MD Helicopters, LLC

***MD500/600 Series
Technical Bulletins Package***

This package contains a complete set of
all Technical Bulletins issued through:

22 August 2023

Figure 1. Typical "T" Instrument Panel and Support Assembly (Sheet 1 of 2)

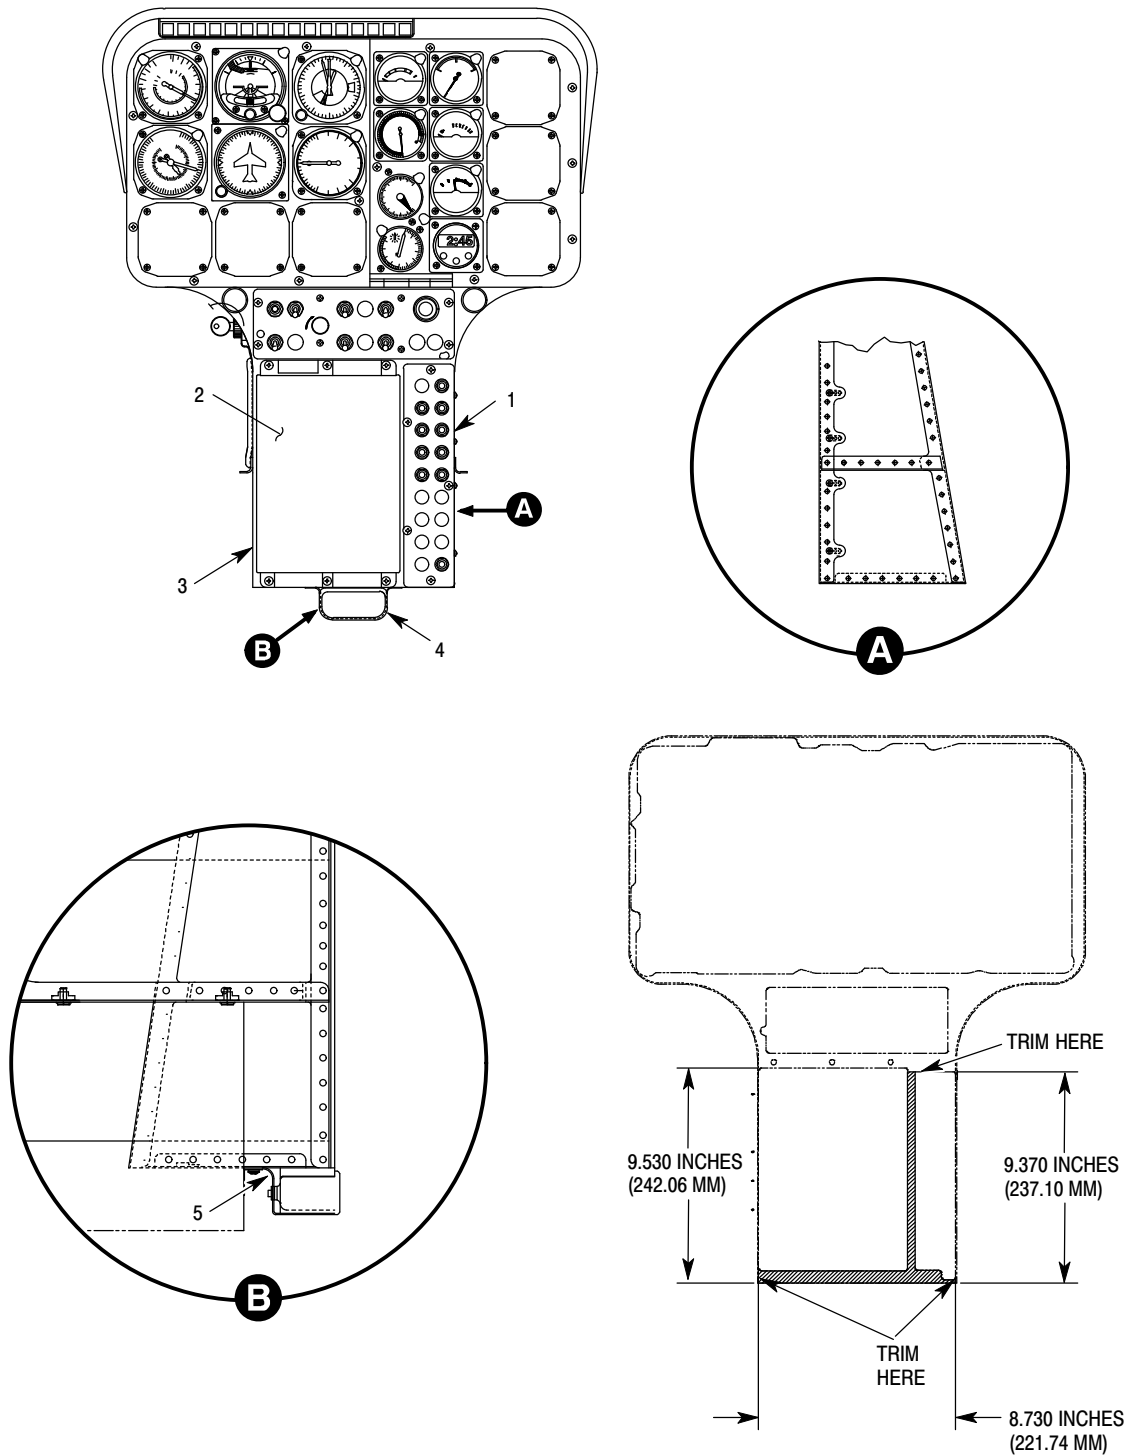
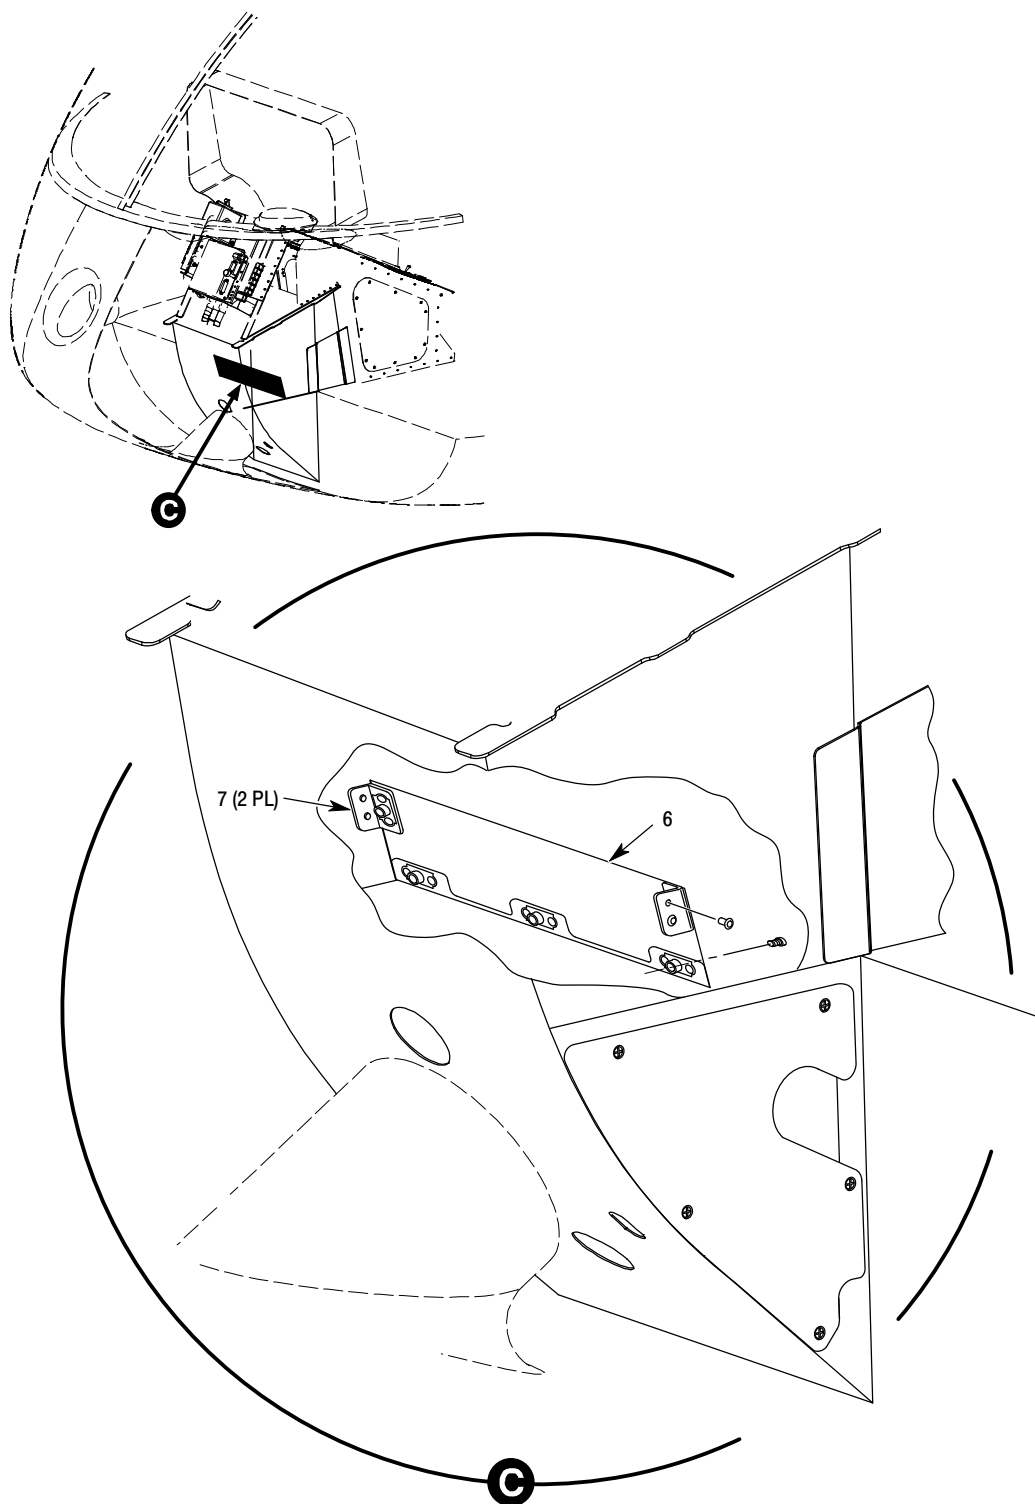
- (1). If necessary, remove panel (2) and attaching hardware from “T” instrument panel.
- (2). Remove box assembly (3) and attaching hardware from “T” instrument panel.
- (3). Remove circuit breaker panel assembly (1) from “T” instrument panel (Ref. CSP-HMI-3, Section 96-30-00).
- (4). Remove circuit breakers from circuit breaker panel assembly (1) (Ref. CSP-HMI-3, Section 96-30-00).
- (5). Remove bottom pan and attaching hardware from “T” instrument panel with ash tray (4) and angle (5) attached.
- (6). Remove support (6) and attaching hardware from instrument support assembly lower panel.
- (7). Remove two clips (7) and attaching hardware from instrument support assembly lower panel.
- (8). Trim the cross hatched area and trim the lower section of the instrument panel structure to the dimensions shown in Figure 1.
- (9). Touch up finish (Ref. CSP-HMI-2, Section 20-30-00).

FIGURE 1. Tailboom Ballast Weight Fabrication and Installation.

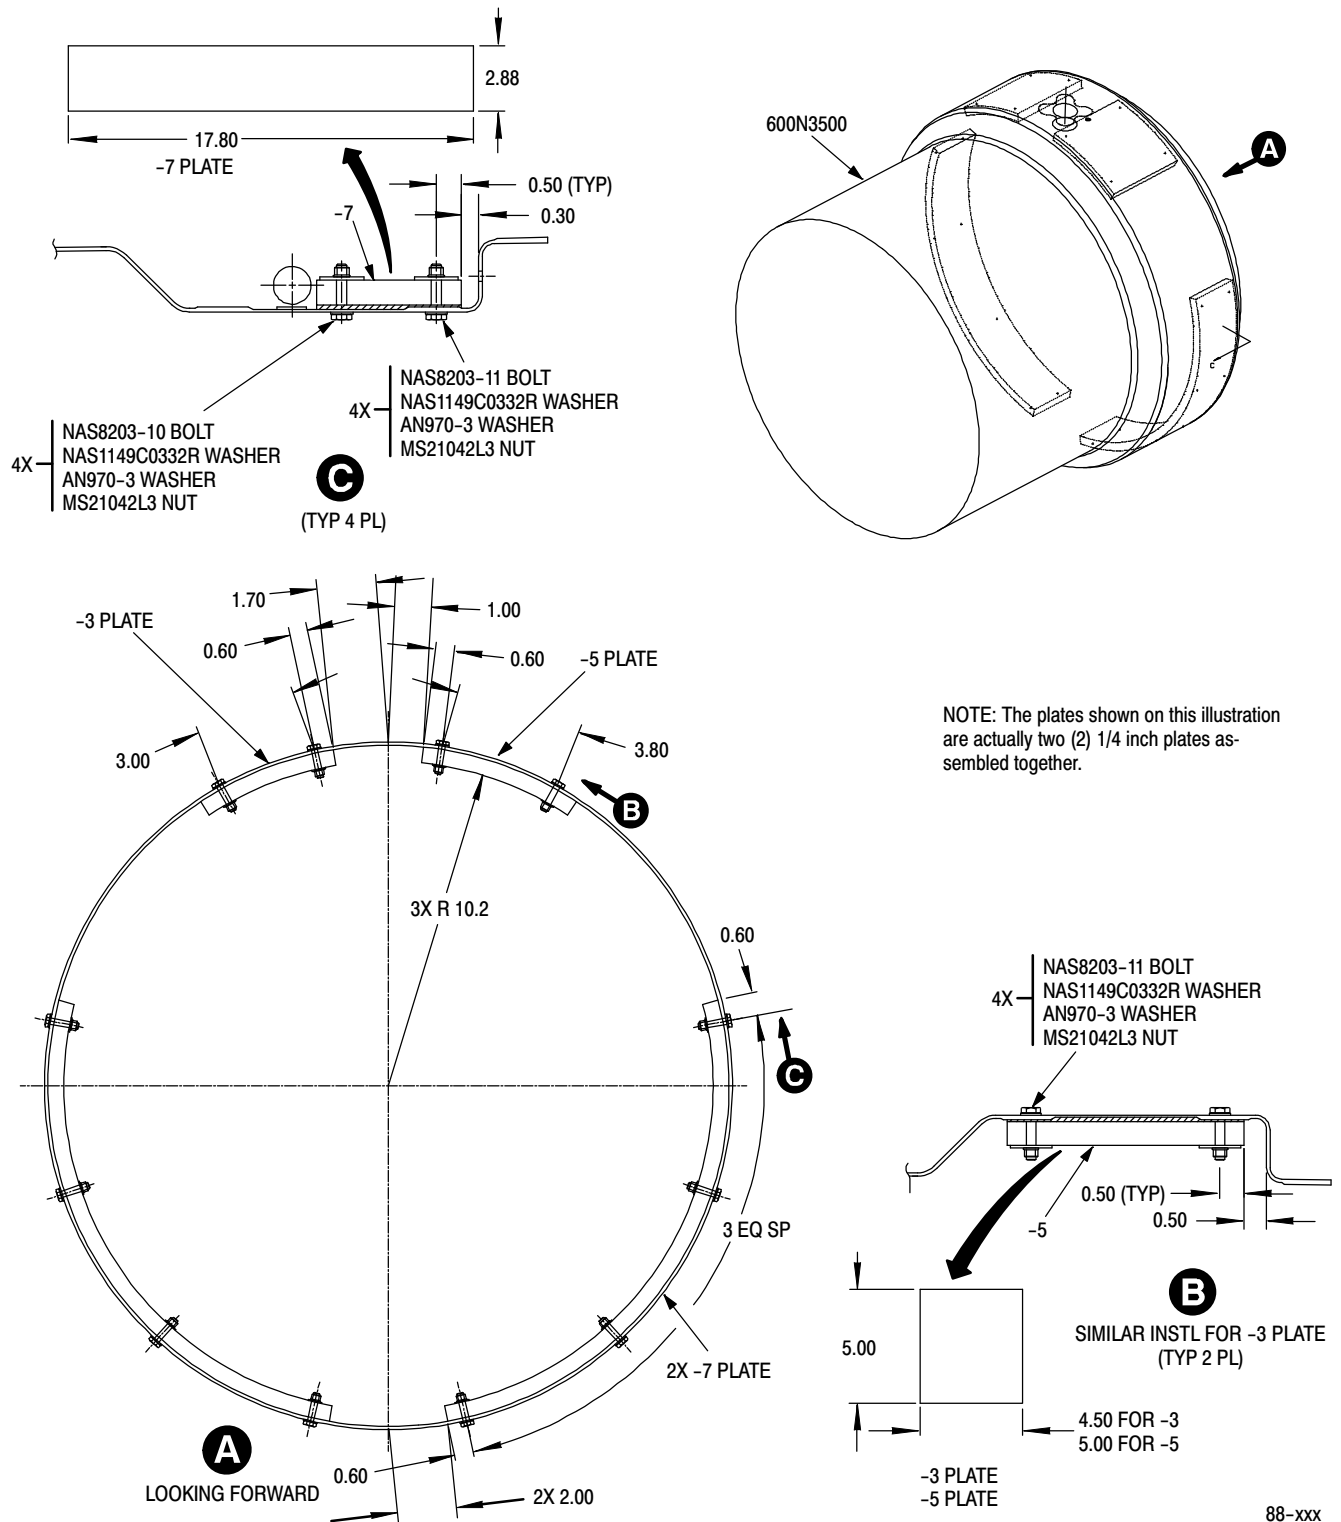
- (7). After the lead has been shaped to fit inside the tailboom, drill pilot holes in the lead with a #30 drill bit. Stack the mating plates together (both -3's, -5's and/or -7's) before drilling in order to get holes to align. Refer to Figure 1 for edge distances.

Figure 2. YSAS Actuator Mount Bracket Installation

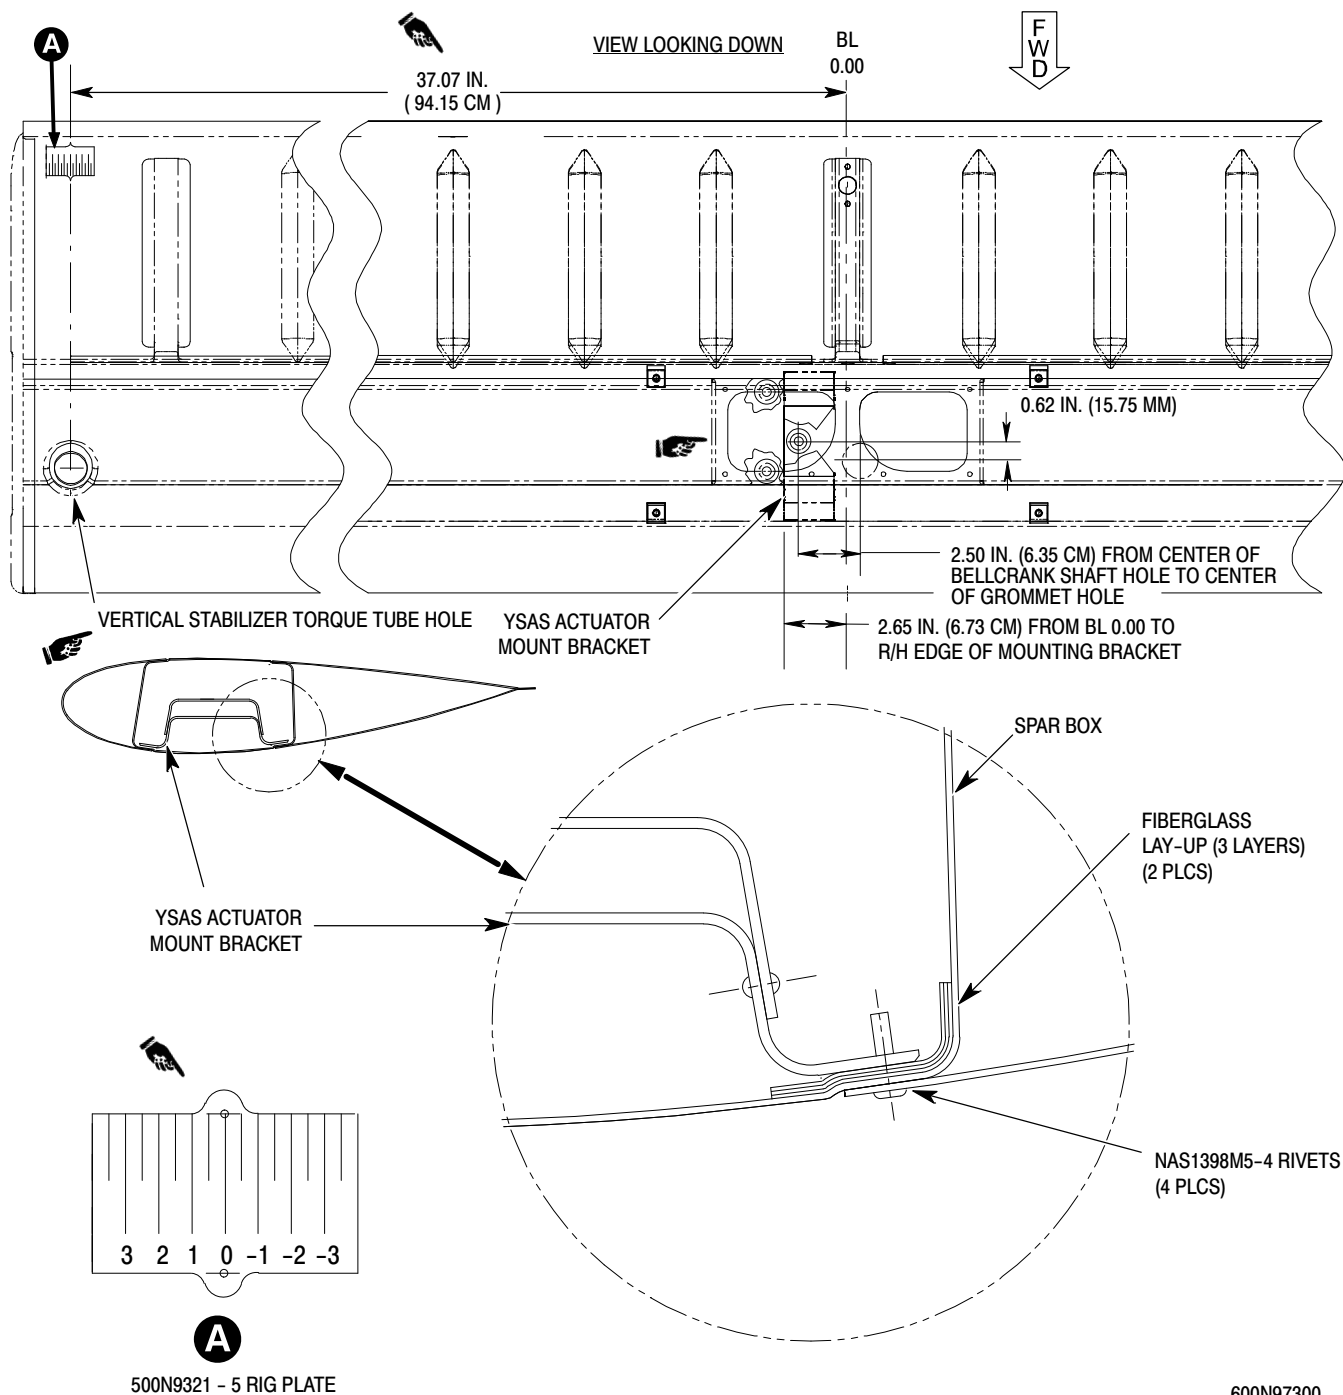
- (c). Assemble tube and actuator with two NAS6603-13 bolts, four AN960-10 (or NAS1149F0306P) washers and two MS21045L3 nuts. Torque nuts to **30 - 40 inch-pounds (3.39 - 4.52 Nm) plus drag torque.**
- (d). Install YSAS actuator with tube onto actuator mount using one MHS626-4-165 bushing, one NAS6204-13H bolt and one NAS1149D0416K washer, but do not do final torque on mounting hardware (Ref. Sec. 67-20-30, S.A.S. Actuator Installation) (Ref. Figure 3).
- (e). Install new bearing races on torque tube (Ref. Sec. 53-50-30, Vertical Stabilizer Torque Tube Bearing Race Replacement).
- (f). Install both vertical stabilizer torque tubes (Ref. Sec. 53-50-30, Vertical Stabilizer Torque Tube Installation).

Figure 3. GTX 345R Modification (Sheet 1 of 2)

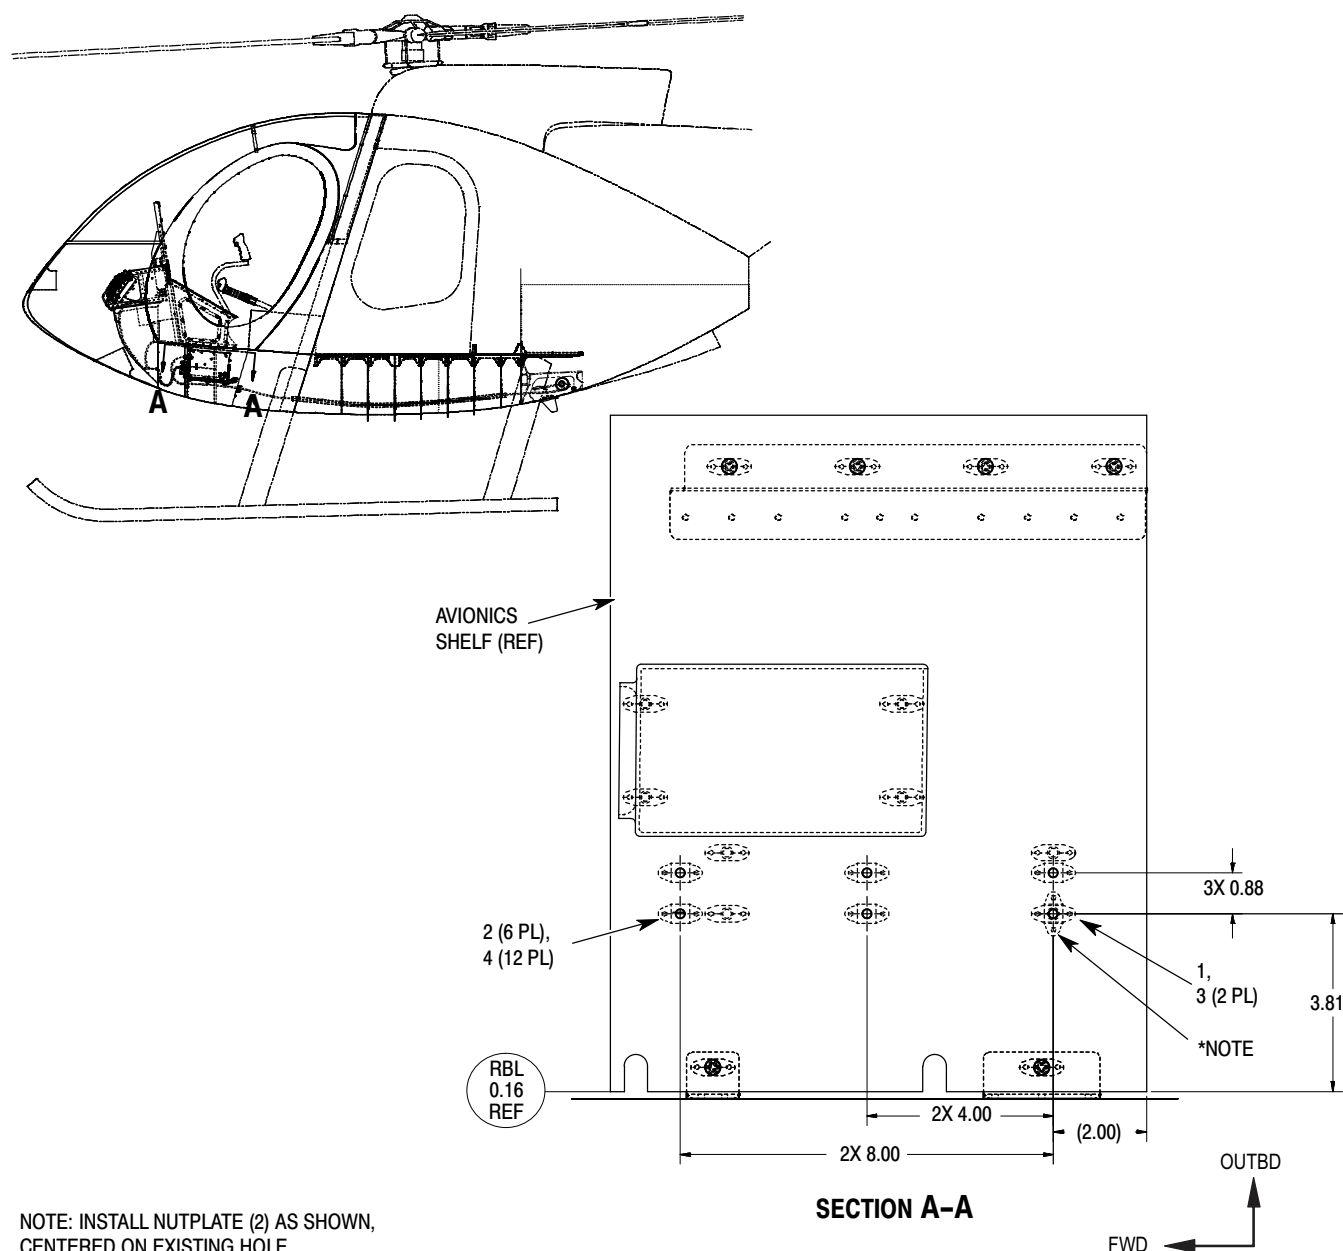
- (6). Remove and discard aft inboard GTX 33H nutplate (Figure 3, 1) and rivets (Figure 3, 3).
- (7). Prepare mounting rack (Figure 3, 6) surface for electrical bonding.
(Ref. CSP-HMI-2, Section 20-50-00)
- (8). Install GTX 345R nutplates (Figure 3, 2) with rivets (Figure 3, 4).
